Amendment #2
Port of Ilwaco Bulkhead Resilience Project

TO ALL PLANHOLDERS AND/OR PROSPECTIVE BIDDERS:

PORT OF ILWACO EAST BULKHEAD REPLACEMENT

Sheet Reference No.
CD-100
INDEX: 9 OF 23

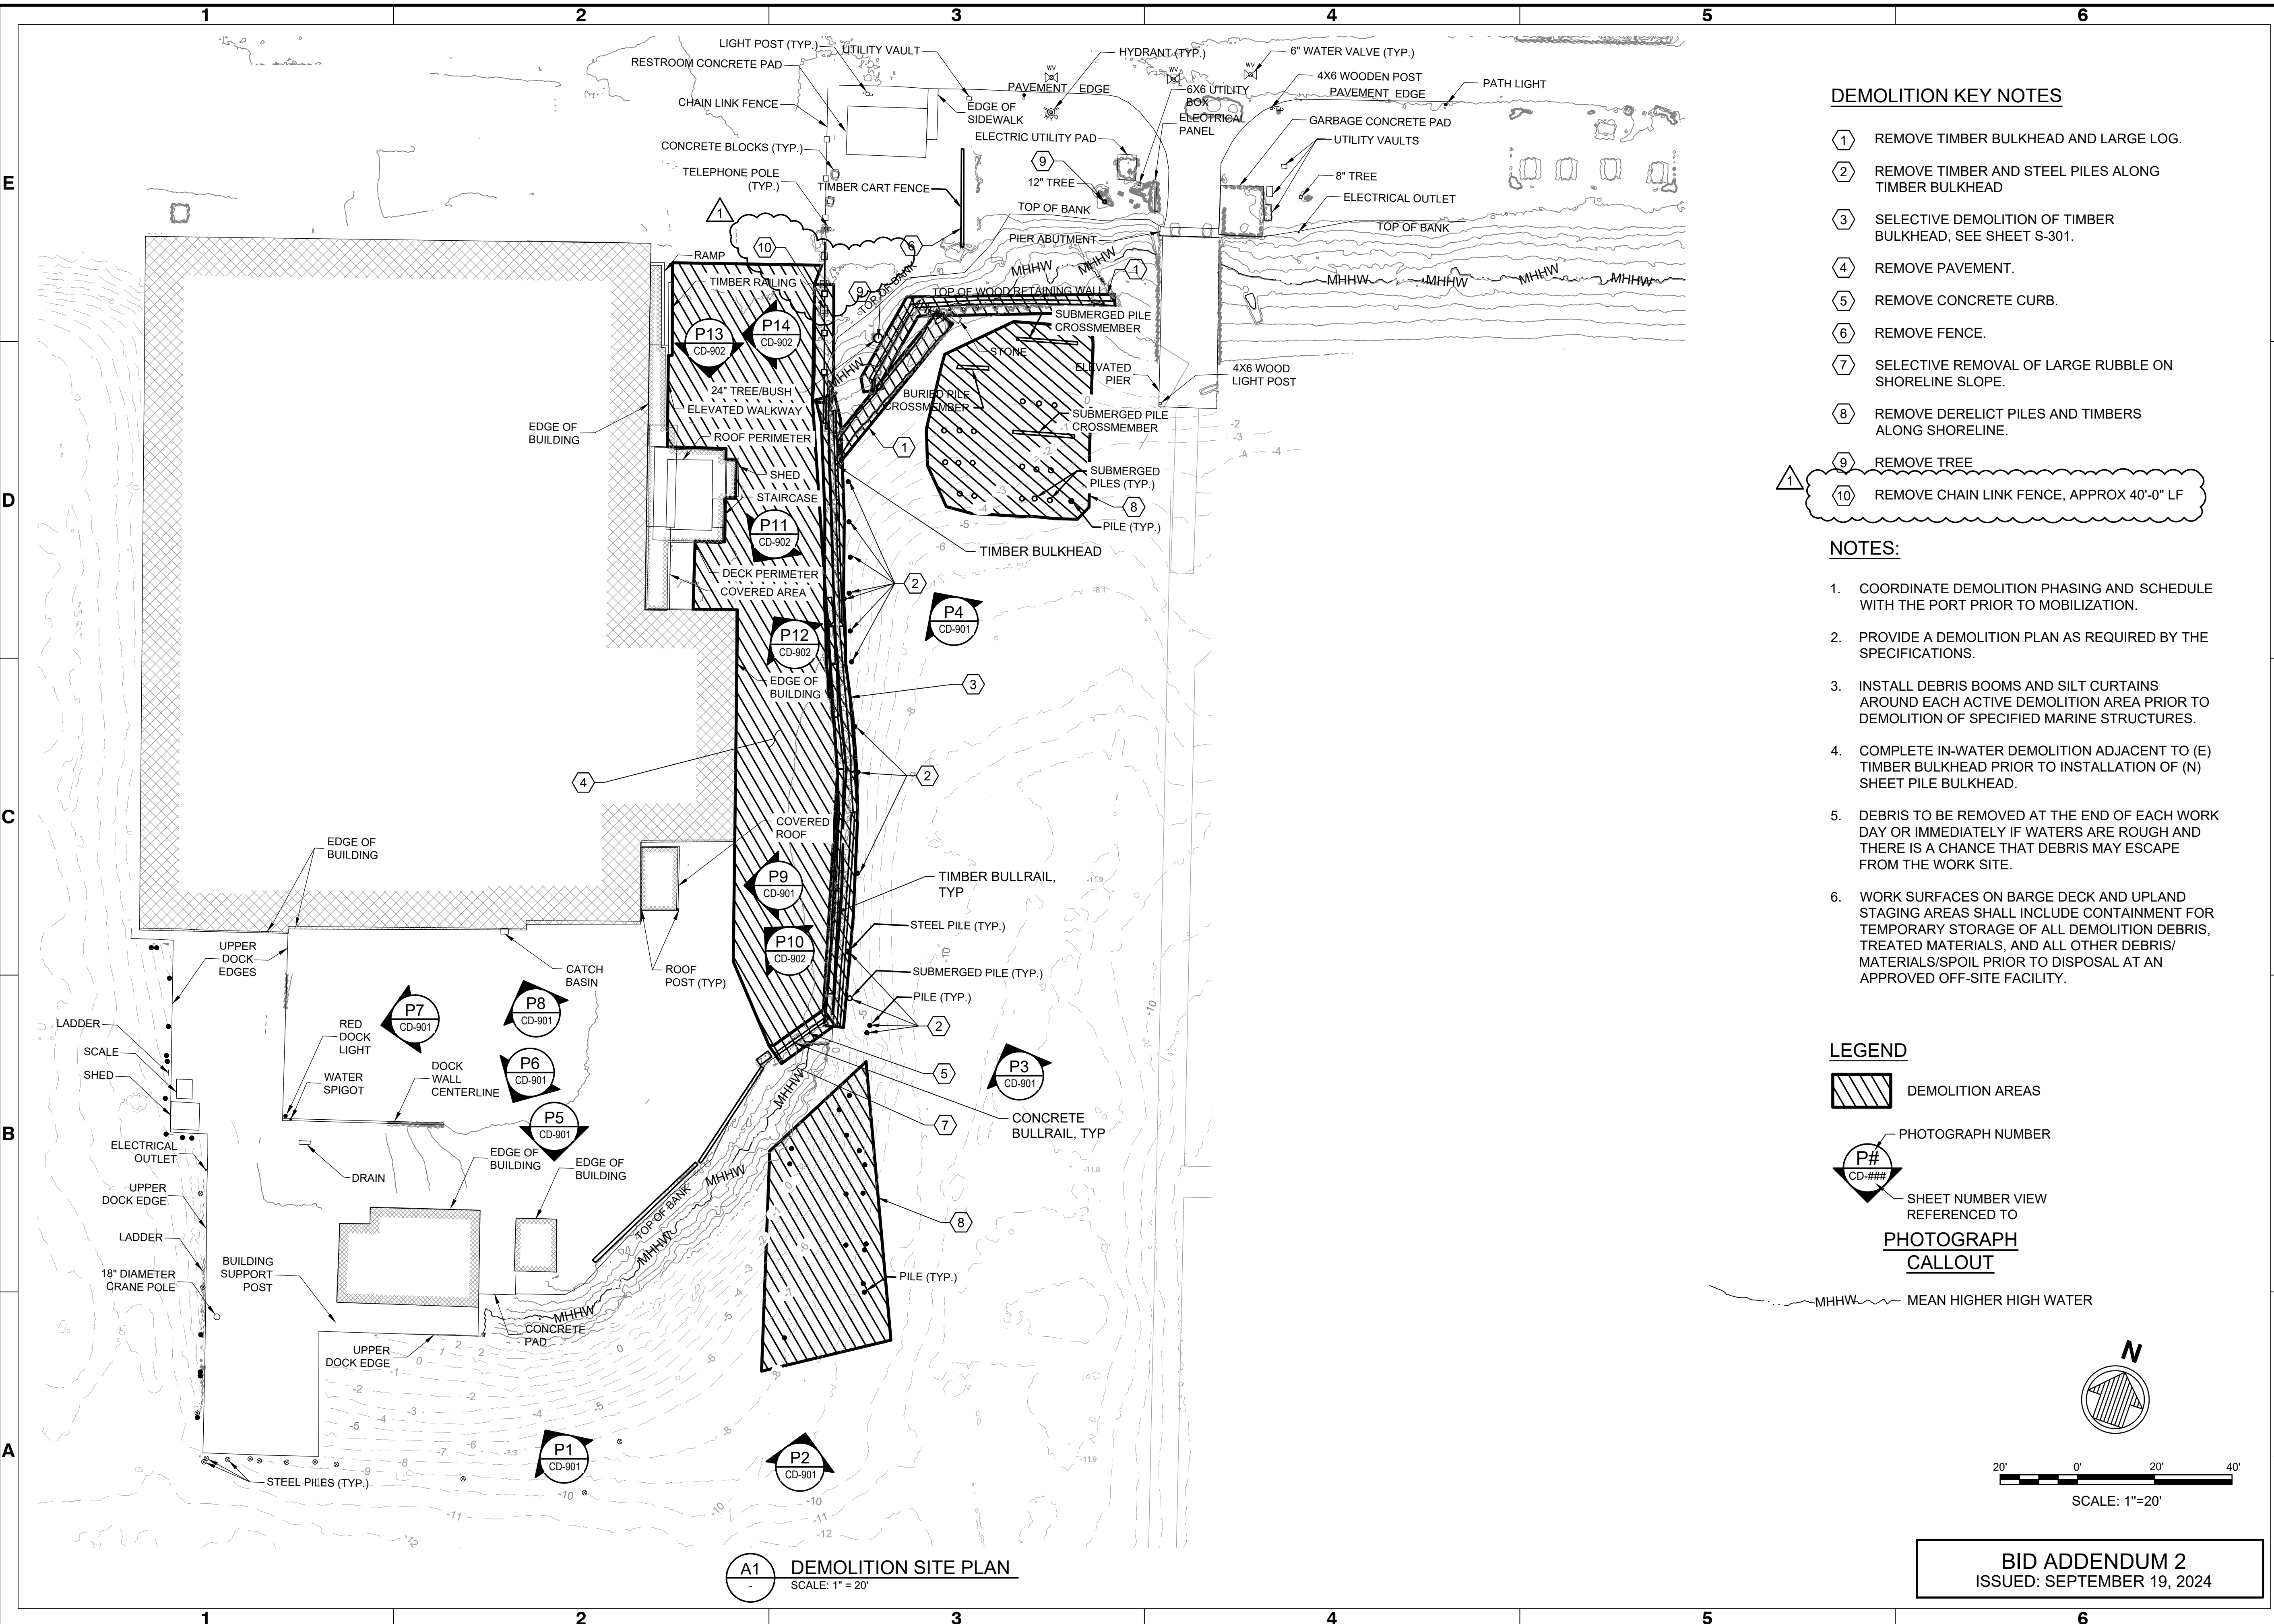
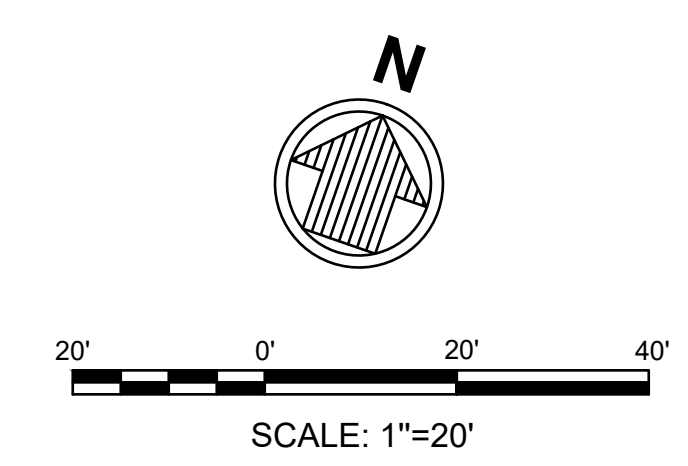
A. The fence detail is used to replace fencing that must be removed to facilitate installation of the bulkhead and berm. Clarification of fence extents have been updated on sheets V-100, CD-100, C-100, and C-110.

Sheet Reference No.
S-100
INDEX: 16 OF 23

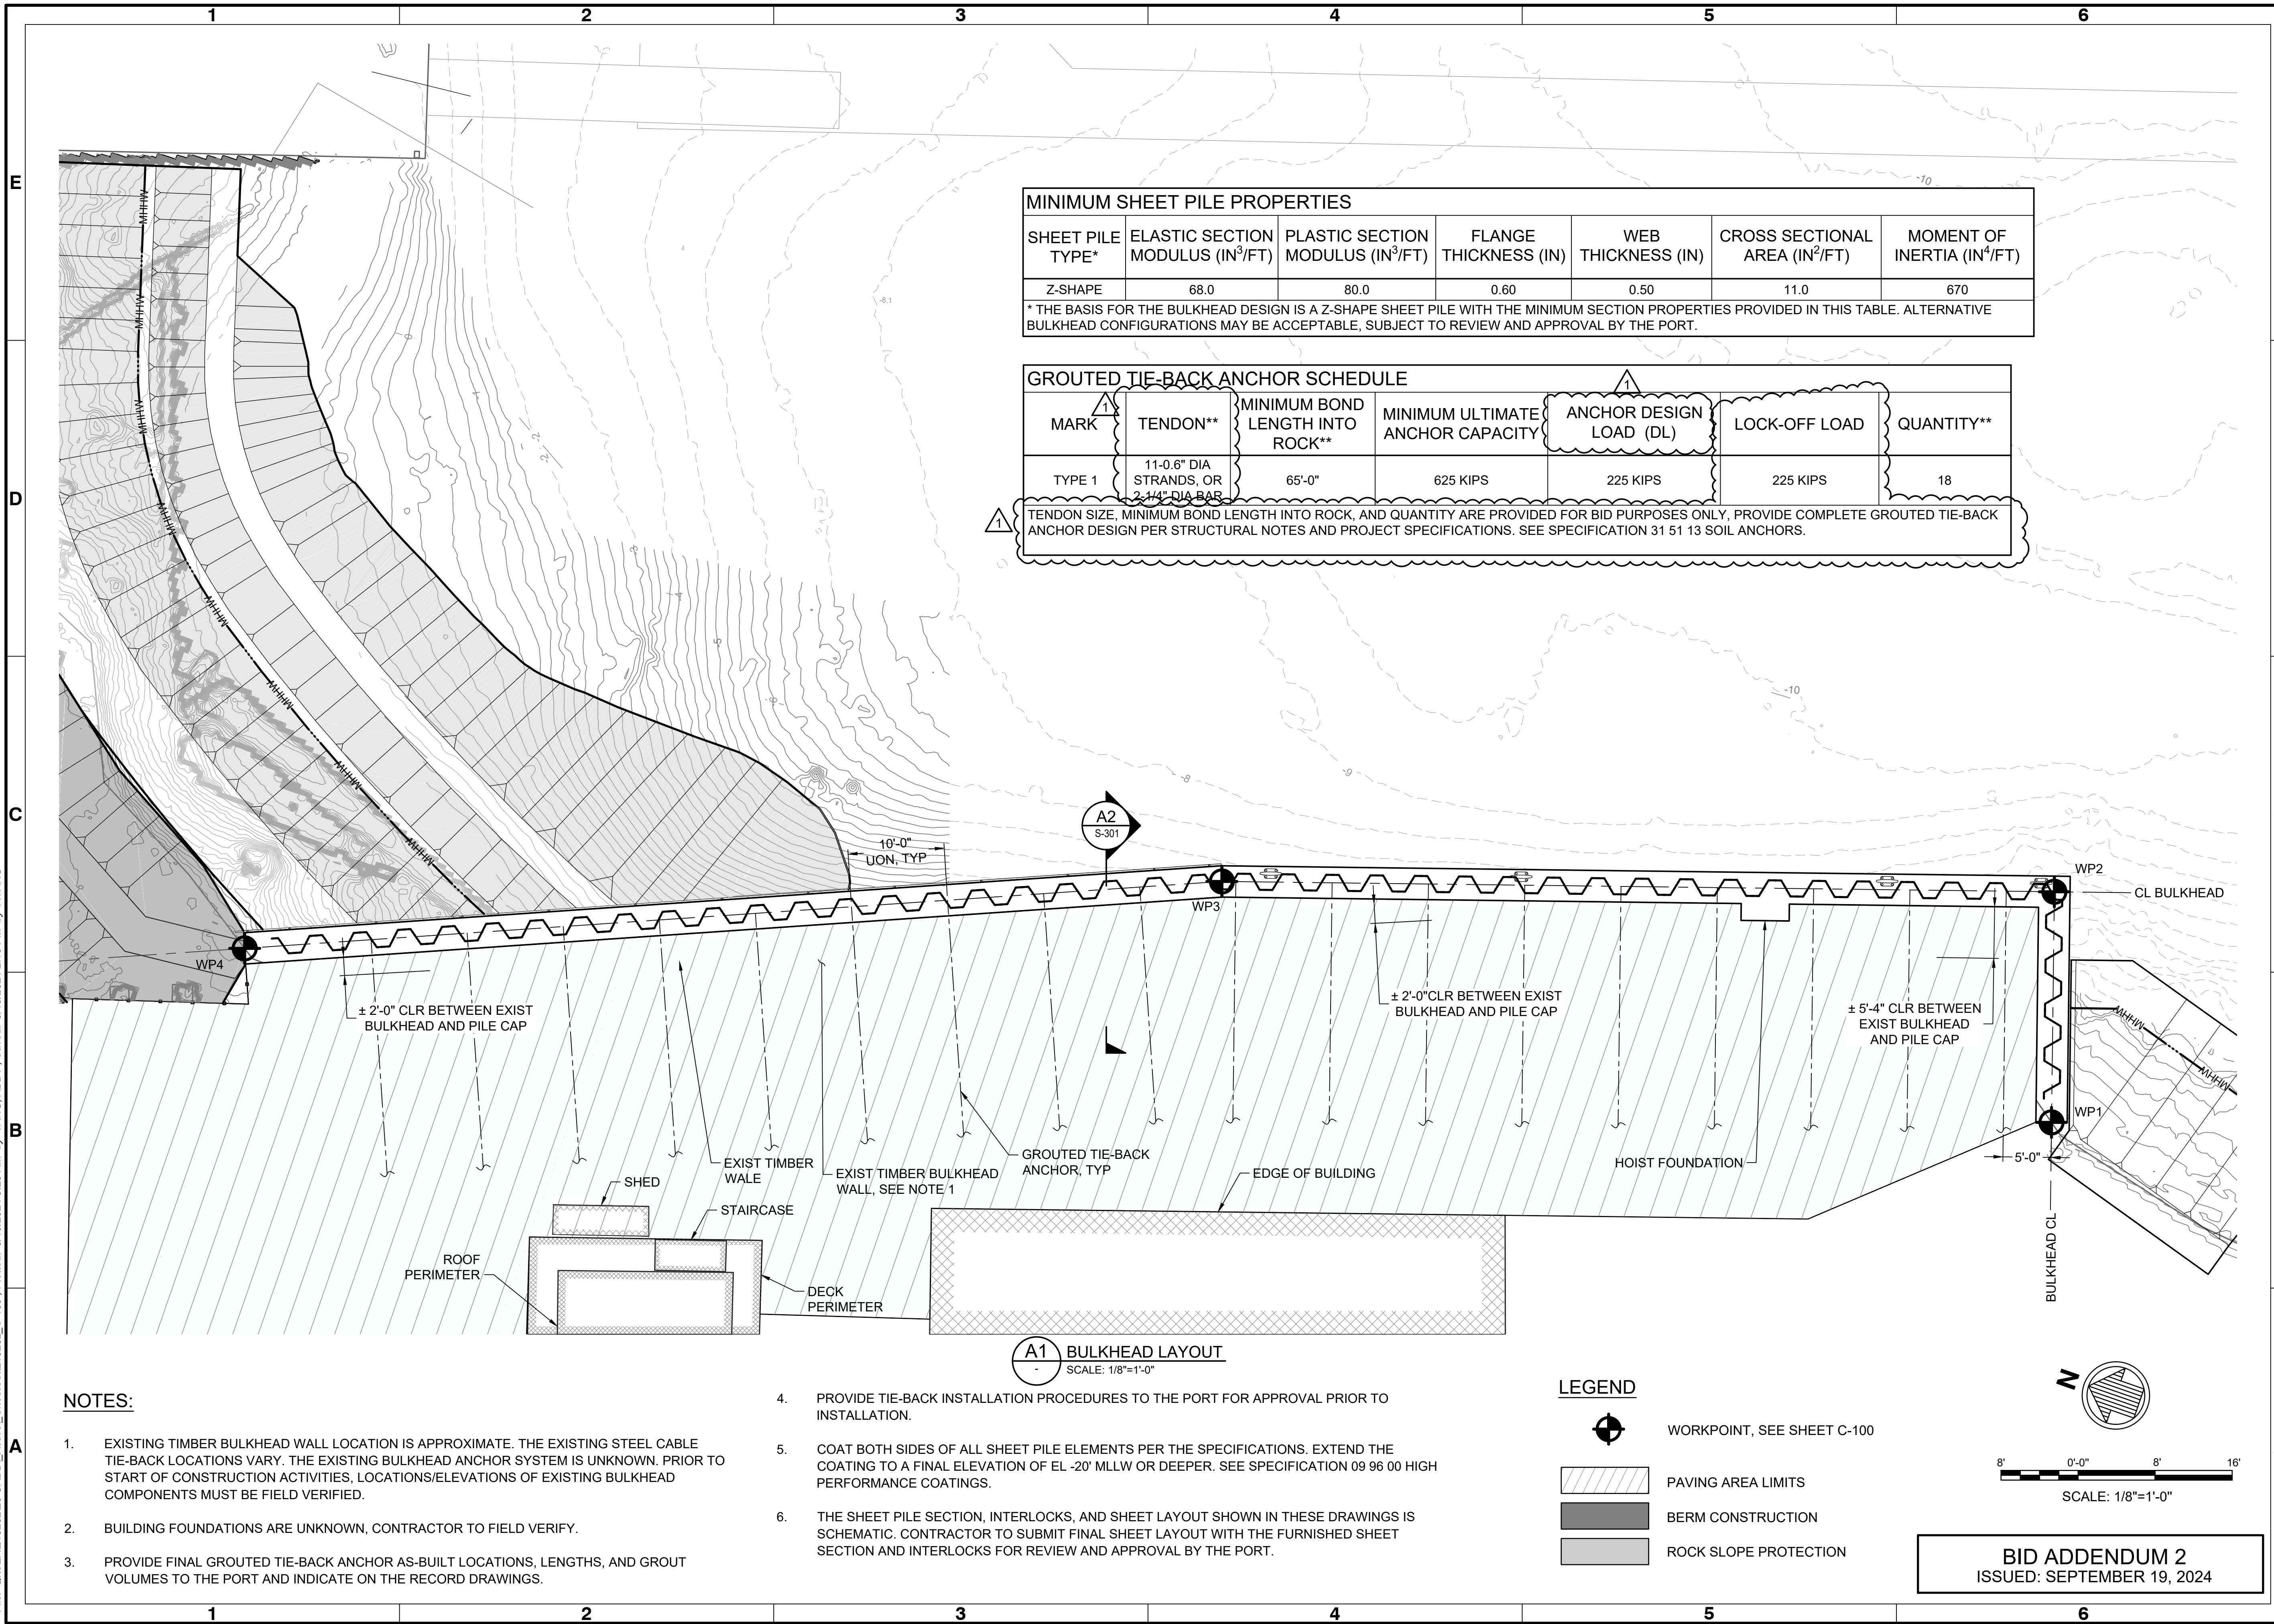
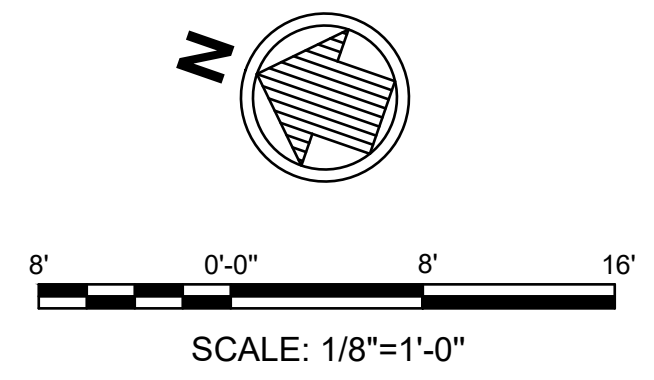
- Clarification of tie-back anchor testing requirements, Sheet G-005.
- Clarification of chain link fence demolition and replacement extents, Sheets V-100, CD-100, C-100, and C-110.
- Specification of tie-back anchor design load, lock-off load, and tendon type. Sheet S-100.

- A. The Design Load (DL) is 225 kips, Drawing S-100 has been updated to reflect this.
 - 3. Sheet S-100 Table GROUTED TIE-BACK ANCHOR SCHEDULE calls for 15ea 0.6" DIA strands per anchor. This is more strands than required to meet the Min Ult Anchor Capacity load of 625 kips. Please clarify the actual number strands required and the alternative minimum size of threaded bar required.**

- A. Bids shall be based on (11) 0.6" strands, or 2-1/2" diameter bars. Drawing S-100 has been updated to reflect this.
 - 4. Sheet S-100 Table GROUTED TIE-BACK ANCHOR SCHEDULE calls for an anchor working load of 225 kips. Is this the intended to be the permanent lock-off load?**

- A. The lock-off Load is 225 kips. Drawing S-100 has been updated to reflect this.
 - 5. Does RCW 39.04.320 regarding apprenticeship utilization apply to this project?**
